TECHNICAL SERVICE BULLETIN

3.5L PowerBoost - Lariat/XLT/XL Trim Levels - Right Side Turbocharger Concerns

24-226423 August
2024**Model:**

Ford 2024 F-150	Engine: 3.5L PowerBoost Lariat/XLT/XL trim level
---------------------------	---

Figure 1

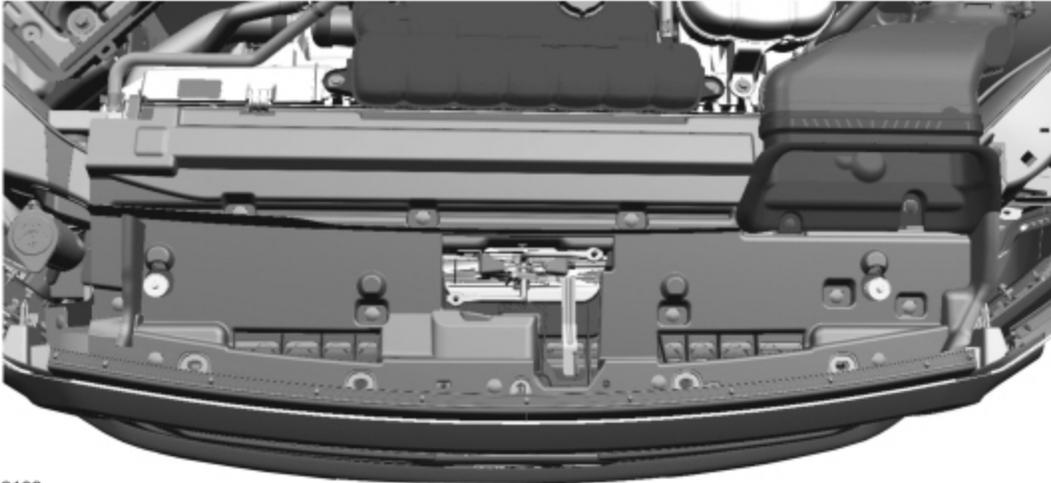
1. Does the upper air deflector match the one outlined in Figure 1?

(1). Yes - proceed to Step 2.

(2). No - this article does not apply. Refer to the WSM for additional diagnostics.

Figure 2

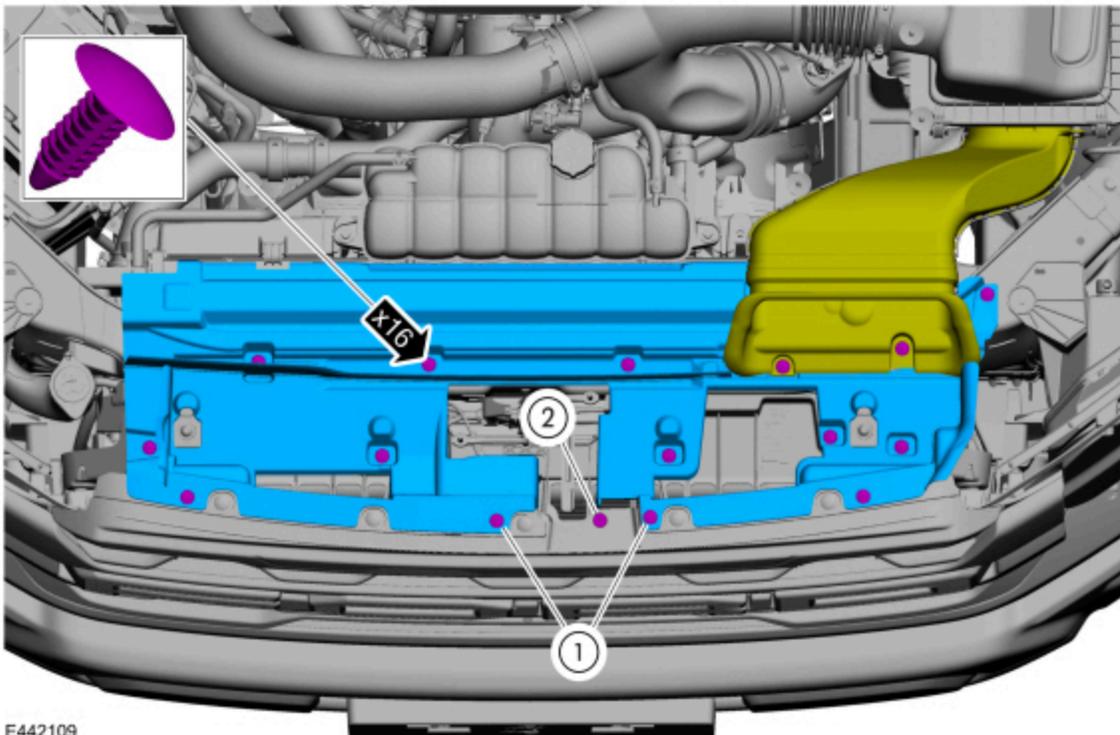
2. Remove and discard the upper radiator air deflector and the 15 air deflector push pin retainers. (Figure 2)

(1). Set the new air deflector in place and install 13 pin retainers except for the 2 shown in Figure 2, Callout 1 and the 1 shown in Figure 2, Callout 2

(2). Using the 2 remaining holes in the newly installed air deflector as a guide, use a 1/4 in. (6.5 mm) drill bit and drill a hole through the radiator grille at each location shown in Figure 2, Callout 1.

NOTE: Use a drill stop or tape set to a 1/4 inch depth on the drill bit as a guide to avoid drilling into components such as wiring on the back side of the grille.

(3). Install the remaining 2 pin retainers to secure the air deflector in place.

(4). Install a single pin retainer in the now exposed hole in the grille as shown in Figure 2, Callout 2.
